Delaware County Regional Planning Commission

AGENDA

Thursday, October 29, 2026 at 6:00 PM
Byxbe Campus Conference Room, 1610 State Route 521,
Delaware, Ohio 43015

20-26 ZON Addison Properties – Orange Twp. – 35.7 acres – FR-1 to PUD (Creekside Glen)

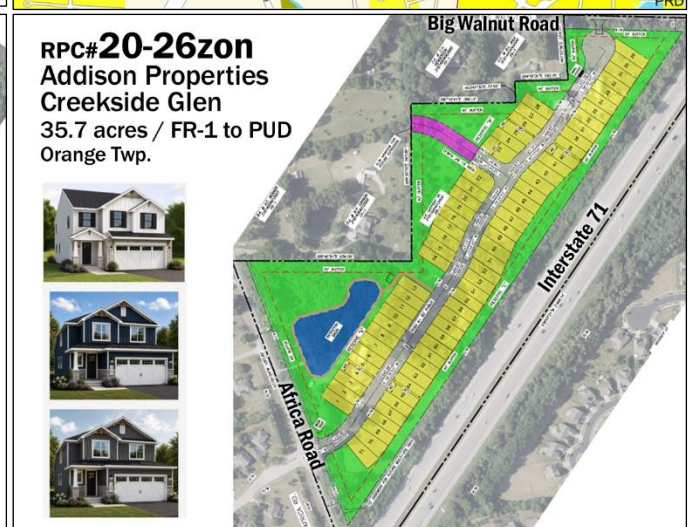
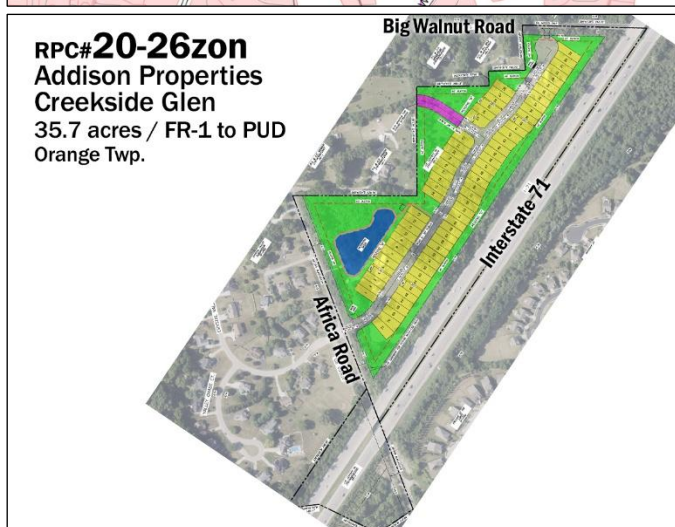
Traffic and access: A single access point to Africa Road and an emergency access drive at Big Walnut Road. The DCEO also approved a Traffic Access Study on October 15th, 2026.

Drainage: Stormwater infrastructure is proposed, which will be treated by the proposed on-site retention pond, and then drain under Africa Road to a stormwater drainage easement in the Crystal Valley subdivision across the street. The DCEO letter notes that a detailed storm water management report will be required during the engineering and development phase. An adequate outlet needs to be identified, and offsite drainage easements and improvements might be required.

Signage: One entry sign is proposed, and an excessive number of other sign types were included in the submittal. A basic entry sign example image was submitted, but did not include dimensions. It is unclear what the intention is, but the "community identity" sign is more desirable than the sample sign showing "Creekside Glen."

Lighting: Street lights are proposed; however, a lighting plan was not provided.

Open Space / Health: The code requires 30% open space (9.12-acres) and the proposal indicates 10 acres, or 33%. The open space indicated is distributed throughout the site, except for the larger area around the retention basin.

As noted, sidewalks are proposed on both sides of the streets. Other than the sidewalks, the proposal shows no

other recreational opportunities or paths except one path located along the edge of the retention pond. There are no existing paths along Africa Road or Big Walnut Road to connect to at this time.

Staff recommends **Conditional Approval** of the rezoning request by Addison Properties from FR-1 to PUD to the DCRPC, Orange Twp. Zoning Commission and Orange Twp. Trustees, subject to the following:

1. *Provide additional pedestrian facilities and clearly identify where the proposed walking path will be located. Indicate the dimensions and material that it will be constructed with and who will own and maintain it;*
 2. *If the township determines that street lighting is required, submit a Lighting Plan as required in Sec. 10.01(C(2)) of the Orange Township Zoning Resolution; and*
 3. *Submit a signage plan for the entry sign as required in Sec. 10.01(C(5)) of the Zoning Resolution (also see Sec. 22.07.A) and provide sign surface area, height, setbacks, etc.*
-

27-26 ZON Palachandra Chickadadi Ganesh – Orange Twp. – 3.35 acres – FR-1 to C-2

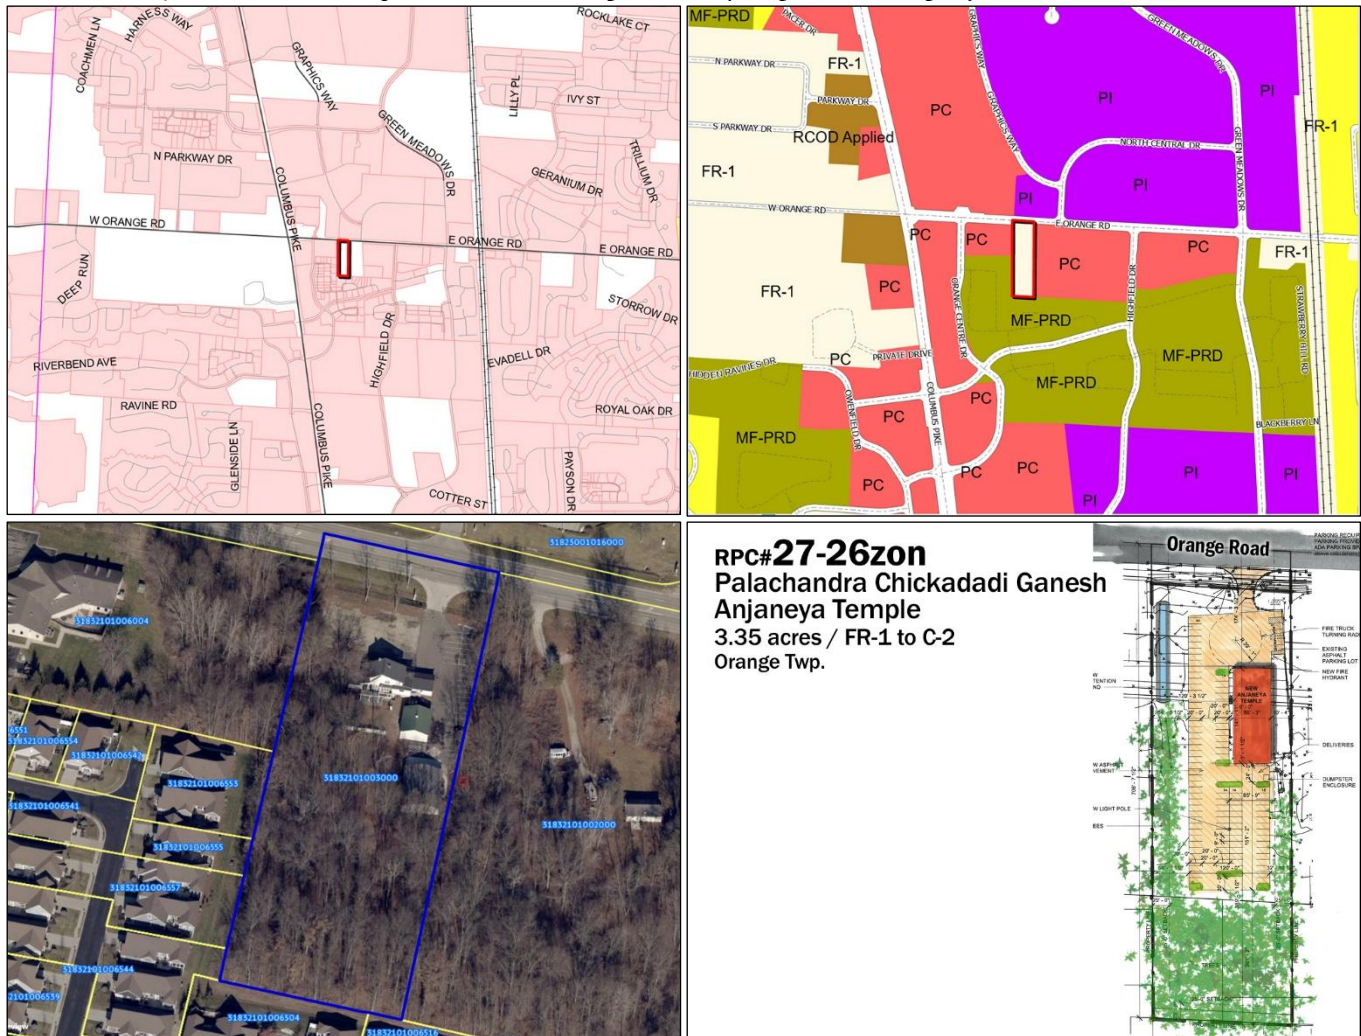
While a site plan is not required, Staff provides the following comments related to the plan submitted as this is an existing use and is expected to expand.

Traffic and access: A single access point is shown on E. Orange Rd. The County Engineer's Office stated that access to/from E. Orange Rd. will be restricted to right in/out only.

Drainage: Drainage will be reviewed by DCEO during preliminary engineering. A zoning permit must also be approved to allow for any improvements to the site.

Staff notes that the Courtyards at Hidden Ravines condominium to the west and south includes a 40-foot-wide drainage and utility easement along the border of this site.

Staff recommends **Conditional Approval** of the rezoning request by Palachandra Chickadadi Ganesh from FR-1 to C-2 to the DCRPC, Orange Twp. Zoning Commission and Orange Twp. Trustees, *subject to:*

1. Update the minimum side-yard setback to 100' when abutting a residential district, with 25' elsewhere.
Minimum rear setback is 100 feet where abutting a residential district, which is the entire rear setback area;
 - a. The Courtyards at Hidden Ravines condos are adjacent to the southwest and south;
 2. Indicate building height on site plan (35' max);
 3. Provide a multi-use path along the frontage; there is an existing path that extends west of Green Meadows Dr. and Highfield Dr., and a crosswalk just east of this property; and
 4. Provide an open space calculation to ensure the minimum pervious surface of 25% is met.
-
